P22-2888

Application Reference: 2024/0373

Re: The proposed erection of building for glass recycling; storage bays; office building, canteen and mess, new vehicular/pedestrian/cycle access with gatehouse, weighbridges and associated works including landscaping at Stairfoot Brickworks, Wombwell Lane, Stairfoot, Barnsley, S70 3NS.

In response to the comments made during our meeting held on the 20th of June 2024 and the further comments made by statutory consultees, this letter details our response and outlines the further documents and plans submitted alongside.

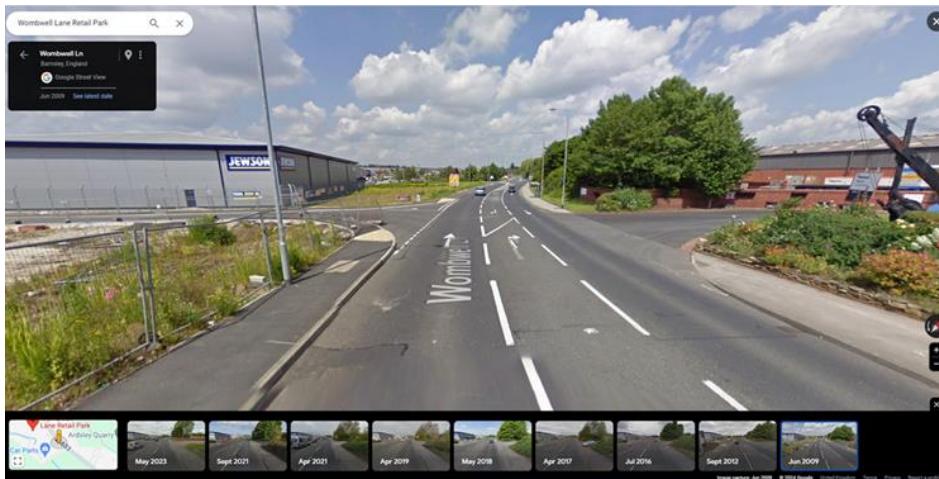
Highways development Control – No provision of a designers check list

“With regards to the design of the site access, I note that we have not been provided a designers check list to ensure that the design is in accordance with the technical requirements as specified within DMRB and that there are not departures from standards. Furthermore, I would advise at this stage that detailed engineering drawings should be submitted to the authority”.

In response to the request for a Designers Checklist I would comment that the access in question is in fact an existing access which is to be the subject of minor kerbline adjustments (on the development side only) to ensure that HGV’s can exit the site in lane and not encroach into opposing lanes on the A633 Wombwell Lane.

There has, therefore, been no wider design work undertaken at the access in terms of its basic geometry such as lanes widths, right turn lane lengths and tapers etc. All these factors remain as existing and would have been considered by the Council when the most recent highway improvement works took place on Wombwell Lane at the time of the development of the trade/retail park on the opposite side of Wombwell Lane to the development site. These works are believed to have been implemented circa 2008 at a time when the Stairfoot Brickworks was still operational as per the google image below:-

Any design checklist would, therefore, be limited to reference to the provision of visibility splays and as such would not be a meaningful document.
